ASK 23 /ASK 23B Technical Note No.11

Product improvement - new trim spring mod.

Installation drawing:

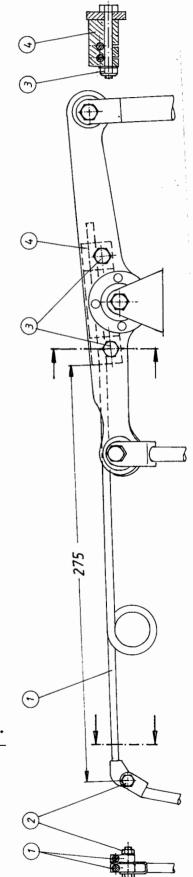
Remove the seat pan and disassemble the existing springs including their mounting.

Then (P/N 99.000.7829) install new trim springs with their (P/N 230.49.0104). mounting, version II spring adjusting dimension of 275 mm must be checked (see drawing). It must be guaranteed that the new trim springs have clearance with full actuation of trim release and full elevator deflection!

After installation of the new trim springs it must checked that the trim is in its center position when the

elevator is neutral.
